Application for Licence Amendment

Licence Number	L9155/2018/1
Licence Holder	Avoca Mining Pty Ltd
ACN	108 547 217
File Number	DER2018/001153
Premises	Higginsville Gold Project HIGGINSVILLE, WA, 6443 M15/351, M15/289, M15/225, M15/642, M15/348, M15/31, M15/786, M15/506, M15/507, M15/620, M15/629, M15/639, M15/640, M15/580, M15/581, M15/597, L15/225, L15/288, L15/302, G15/19, G15/23, M15/528, M15/231, M15/748, M15/512, M15/352, M15/610, M15/375, M15/338, M15/1790, M15/1814, L15/282, L15/347, G15/26, G15/27, G15/29, L15/382, L15/389, M15/325, M15/681 and M15/817. As defined by the Premises maps attached to the Revised Licence
Date of Report	26 October 2020
Proposed Decision	Granted

Licence L9155/2018/1 is held by Avoca Mining Pty Ltd for the Higginsville Gold Project (the Premises), located at Higginsville WA.

Figure 1 Location of existing monitoring bores, proposed seepage recovery and proposed compliance monitoring bores (Rockwater, 2020)

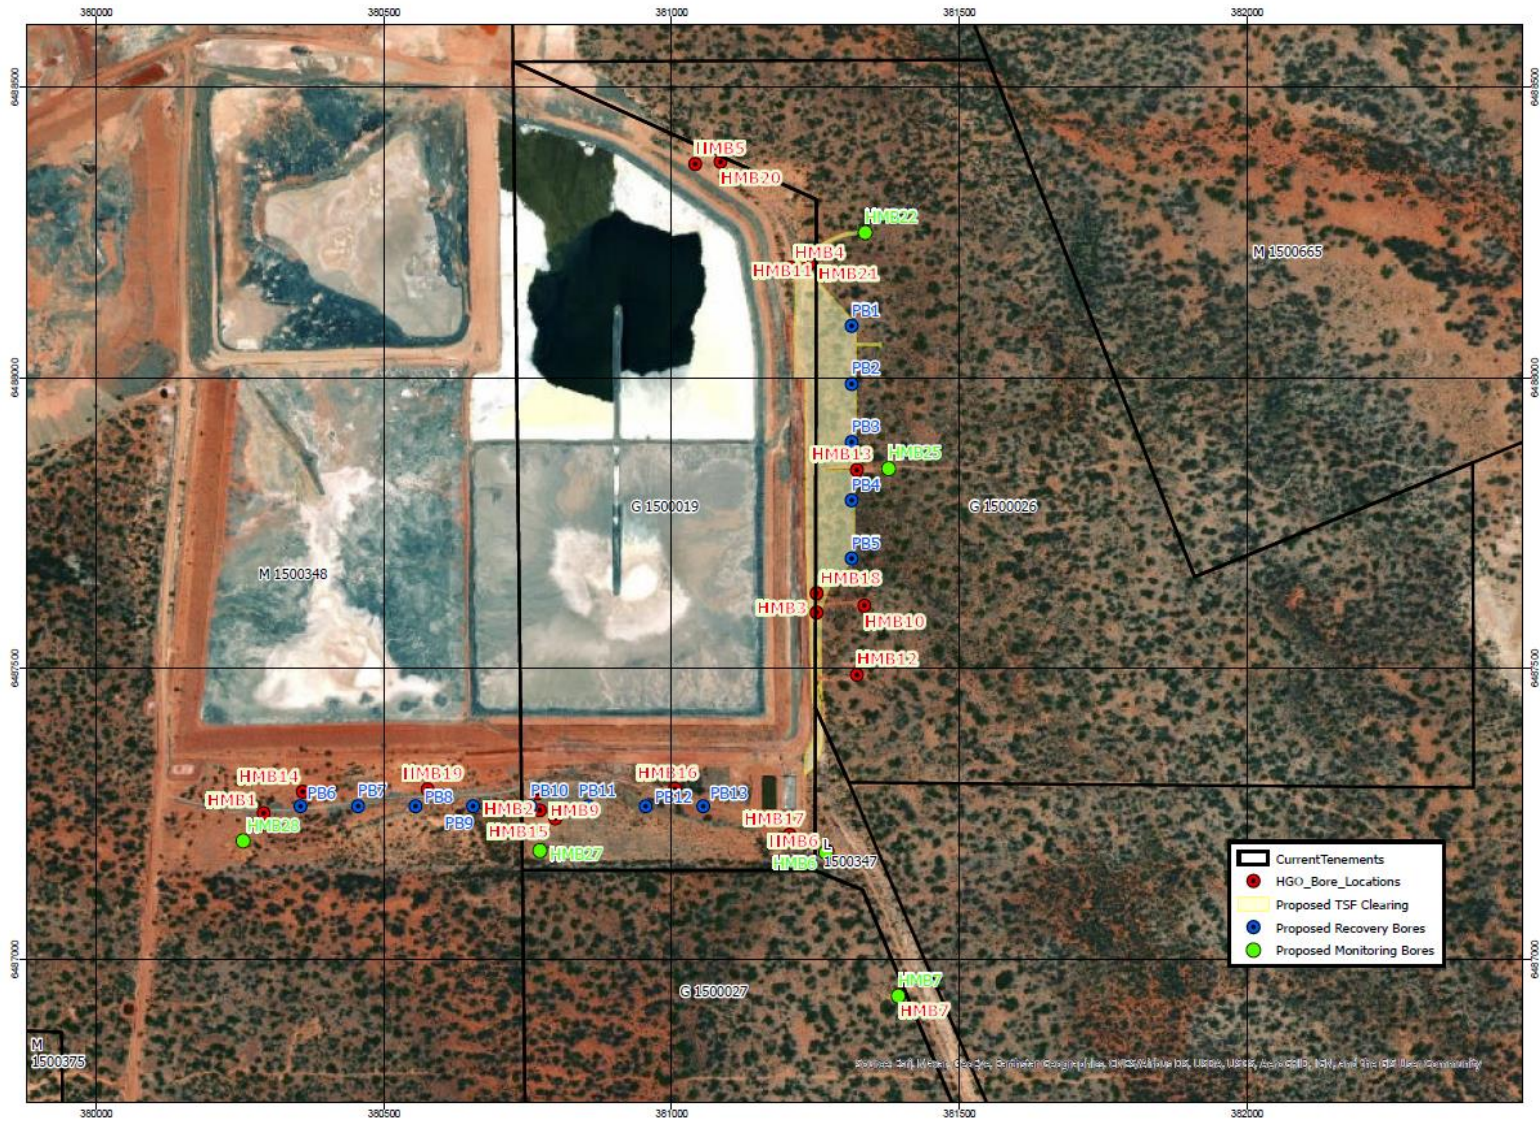
Rockwater suggests that bores HMB6, 7, 22, 27 and 28 should be used for compliance monitoring and that some modifications to bores may be required to make them comply to industry standard guidelines. In addition to these, the applicant has also proposed that HMB 25 be used for compliance monitoring.

Additionally, the construction of the applicant proposed new monitoring bores (HMB22 – 28) is insufficient for their addition to the licence as compliance monitoring bores. Consequently a requirement for installation of a minimum of four additional groundwater monitoring bores to the east and south east of TSF2-4 (HMB29, 30, 31, 32) has been placed on the licence (condition 1.2.6). Monitoring wells (HMB1, HMB3, HMB4, HMB5, HMB6, HMB7 and HMB9) will remain on the licence as compliance bores for the purposes of trend analysis. The department may reconsider these wells later once data has been accumulated for the new monitoring well network.

Figure 5 TSF 1- 4 monitoring bore standing water level trends (AER 2018-2019)

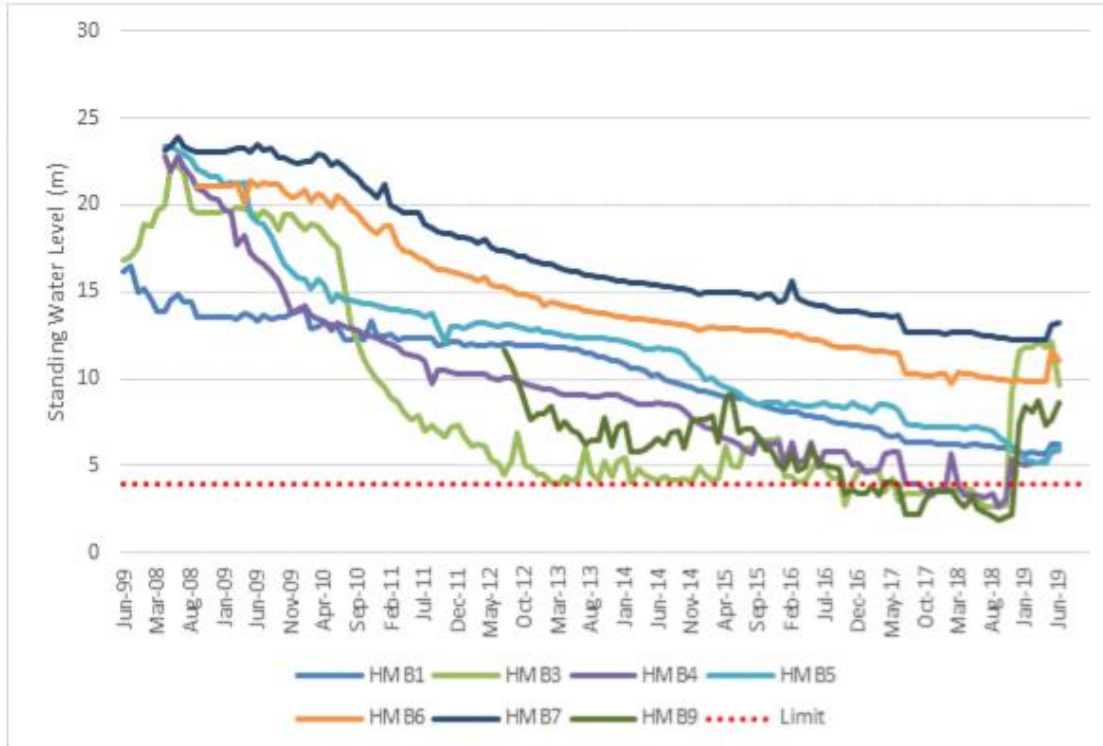
Monitoring results for the 2018-2019 Annual Environmental Report (AER) provided under the current licence conditions, demonstrates groundwater mounding surrounding TSF1-4, whereby monitoring bores HBM3, HBM4 and HBM9 (Figure 4) breached the licence limit (groundwater to remain >4m bgl) on four instances in 2018 (Figure 5). Rockwater (2020) also indicated that HMB2, 13-16, 18, 19, 23, 24, 26 and 27 (which are not currently DWER compliance bores), had water levels shallower than the DWER trigger level of 4m bg when measured in May 2020. HMB26 was measured with the shallowest standing water level of 1.2mbgl.

Water levels have been shown to rise substantially since 2008, including HMB7, the furthest bore monitored, located 450m south east of the TSF where water levels have risen by 10m. Rockwater (2020) indicates that seepage is greatest along the southern margin of the TSF where a groundwater mound has developed, centering on bore HMB9 (which has since been pumped) and along the eastern side of the TSF, centred on bore HMB23. Water level rise closely correlates with proximity to the closest active cell.

Pumping from bores HMB3, 4 and 9 resulted in low drawdown. Rockwater therefore indicated that either a large number of closely spaced, low-yielding recovery bores; or a lower number of widely spaced, high-yielding recovery bores is required to control the groundwater mounds. These have yet to be installed and are proposed for seepage management for continued use of TSF2-4. The use of monitoring bores as recovery bores was flagged as an issue for data accuracy during a compliance inspection by DWER on 22 August 2019.

After conducting a risk assessment (see section 3 of this report), DWER finds that the risk of continued seepage associated with operation of TSF2-4 remains high. Condition 1.2.8 has been placed on the licence indicating the licence holder may deposit tailings into TSF2-4 (pre and post amalgamation) for twelve months only and must provide a report to the department indicating the proposed controls are adequately managing seepage nine months after the date of licence amendment issue. The licence holder may apply for a new licence amendment for continued use of TSF2-4 at this time.

Figure 6 TSFs 1-4 Monitoring Bores WAD CN trends (AER 2018-2019)

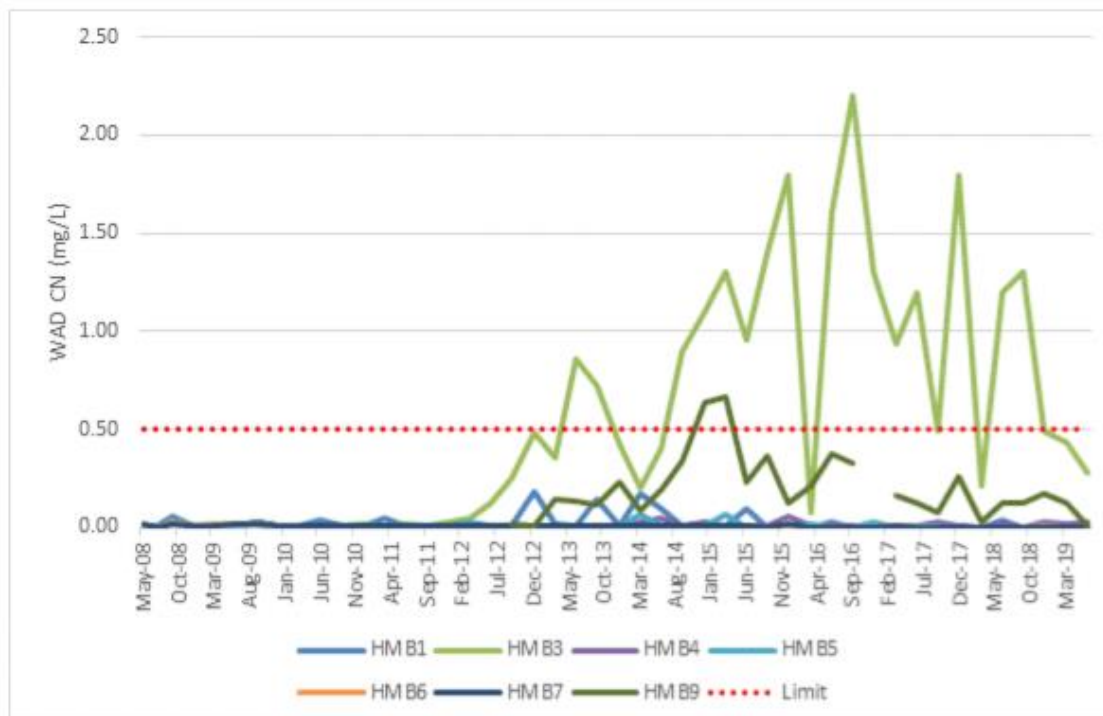
Historical data presented in the 2018-2019 AER indicate that HMB3 and HMB9 have also previously exceeded weak acid dissociable cyanide licence (WAD CN) limits (licence condition 3.5.1 – WAD CN limit of 0.5mg/L) (Figure 3). The highest level reported was for HMB3 which returned 2.2mg/L in 2017. HMB2, which collapsed and was replaced by HMB9 (as a compliance bore) in amendment notice 1 (issued January 2019), has also historically exceeded the licence limit for WAD CN (Rockwater, 2020).

Figure 8 Bennelongia 2016 sampling locations

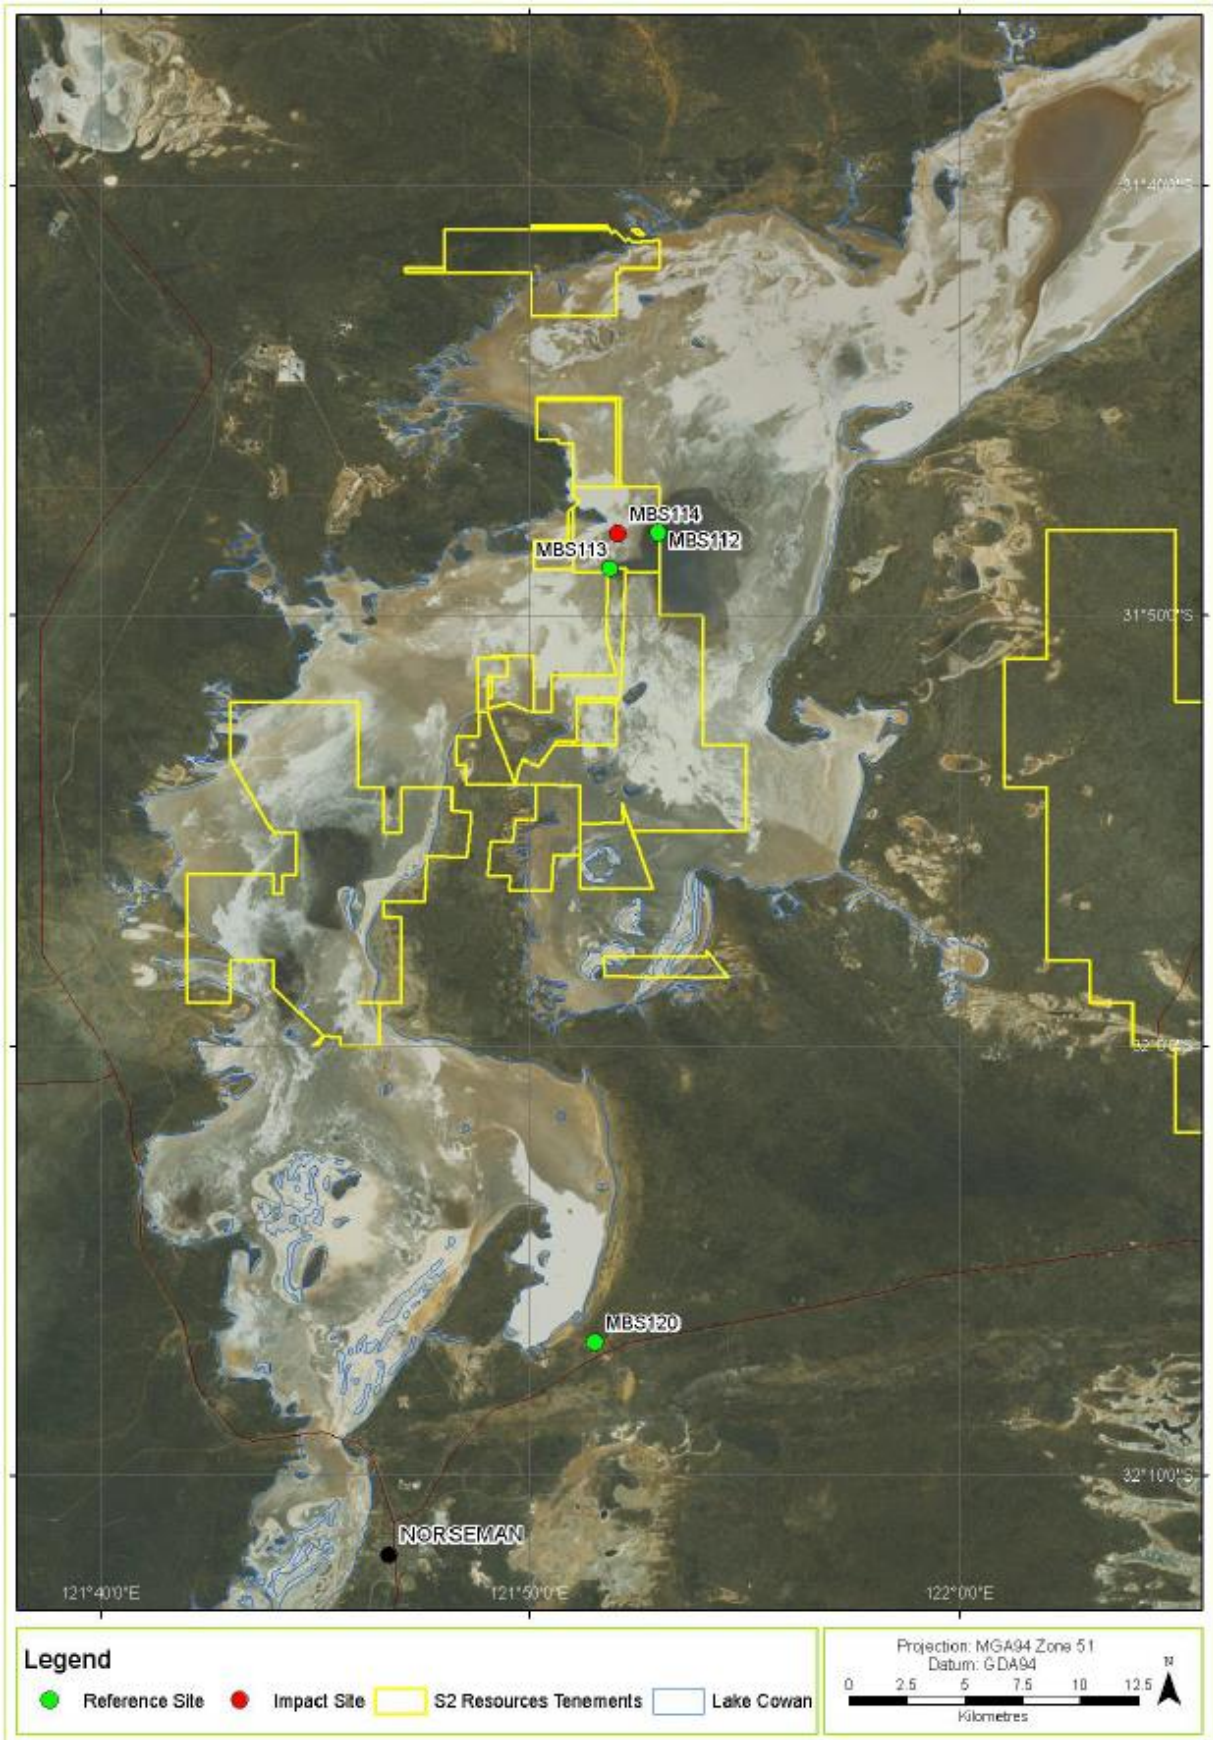
Reporting by Actis 2020 on aquatic invertebrate fauna and flora is limited. Condition 3.2.1 of the existing licence requires sampling of diatoms and macrophytes. The report speaks mostly of Bennelongia results in 2016 and the only mention of sampling in 2020 is that “amphora sp, Navicula sp and Nitzschia frustules were found during sampling in 2020”. No results from the diatom surface scrapes which were collected were provided with the report.

Data provided by the Actis (2020) with respect to Lake Cowan is limited with respect to aquatic biota and did not meet requirements of licence conditions 3.2.2. Consequently, the department is limited in its ability to assess impacts of dewatering currently approved and therefore the impact of additional dewatering proposed. Therefore, this activity has only been partially approved under this assessment to allow dewatering for six months for half of the additional quantity applied for in this amendment.

A full set of monitoring results as required by condition 3.2.2 are to be submitted to the department within six months after this licence amendment has been issued. This requirement has been placed on the licence as condition 2.2.2. See Table 12 below for a comparison of Actis results to the licence conditions. The licence holder may apply for a new licence amendment for the remaining quantity required for dewatering after results required by condition 3.2.2 have been provided.
